寄件者: [REDACTED]
寄件日期: 2026年09月24日星期四 11:18
收件者:
主旨: Planning Application No. A/NE-TK/866 - Departmental Comments
附件: 2026-08-25 17 Cafe-Layout (revised).pdf; 2026-08-27 17 Cafe-Layout(with vehicular access).pdf; 2026-08-21 route to bus stop.pdf

Planning Application
Proposed temporary
eating place(cafe) for a period of 3 years

Site Plan

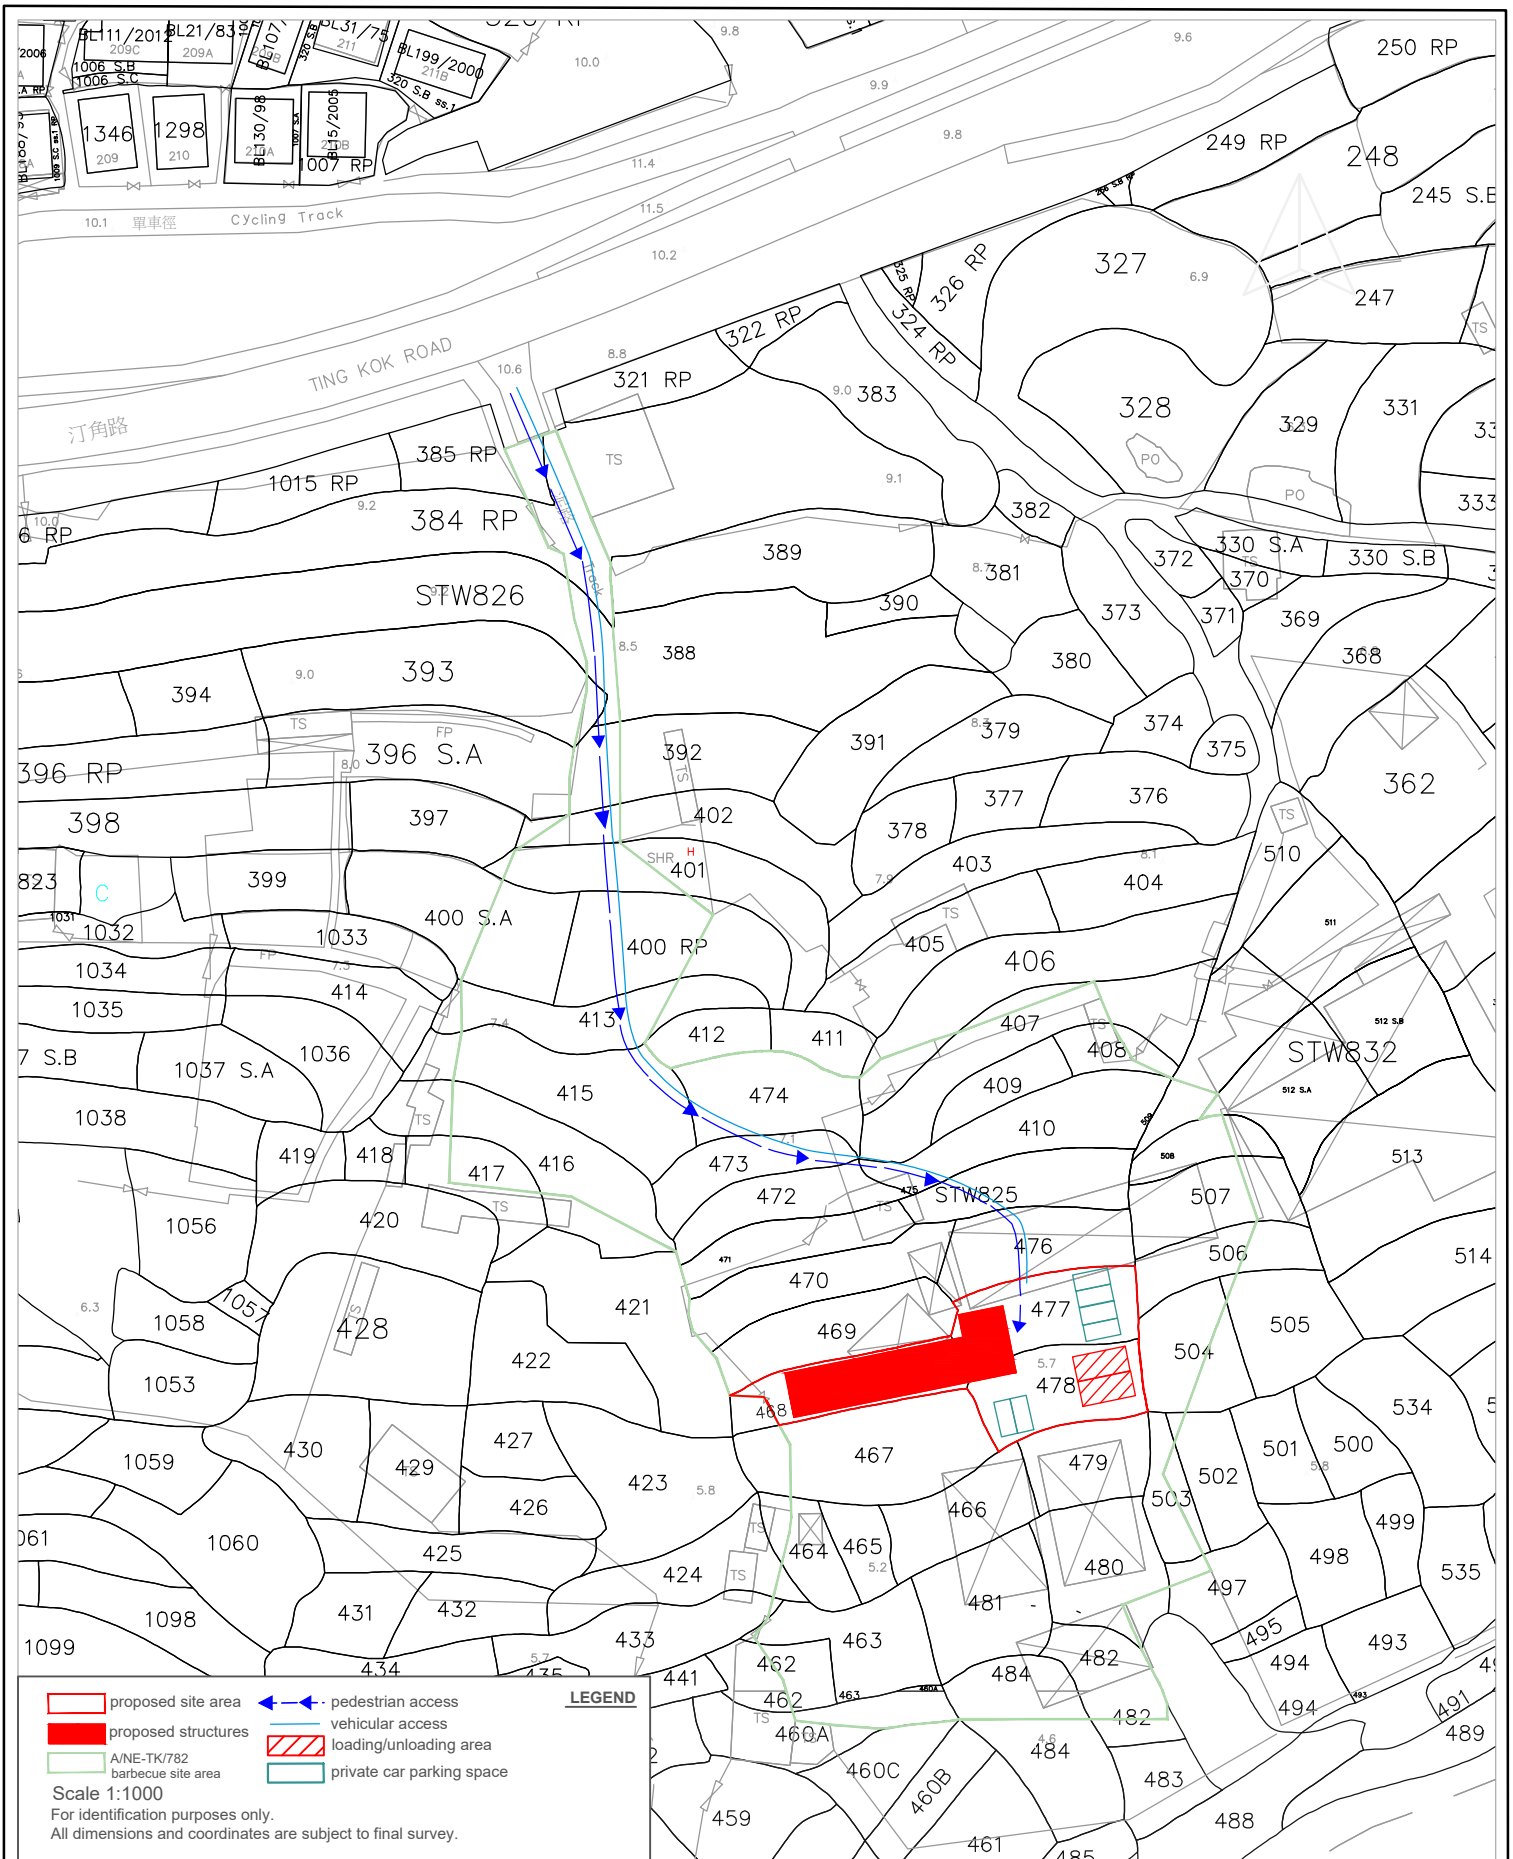
In response to the comments from the departments, please find the attached additional plan showing the route from the village road junction to the nearby bus stops, as well as the revised site plan indicating the vehicular access, pedestrian access, and the loading/unloading area.

In regard to the Planning Department's comment, we would like to clarify that except for the newly added private car parking spaces and the revised loading/unloading area, the remaining open space will be kept as a car-turning area and access (circulation purpose), ensuring that there is sufficient space to drive away and access for pedestrian, and the revised plan is enclosed for your review.

To resolve the concern of the Transport Department regarding parking space, the site will add 6 private car parking spaces (5m x 2.5m) within the uncovered area, so as to effectively absorb the traffic flow that might potentially arise from the 50 people (upper limit), ensuring that the application possesses self-sufficient absorption capability and will not affect surrounding public parking facilities or lead to vehicles illegal parking problem.
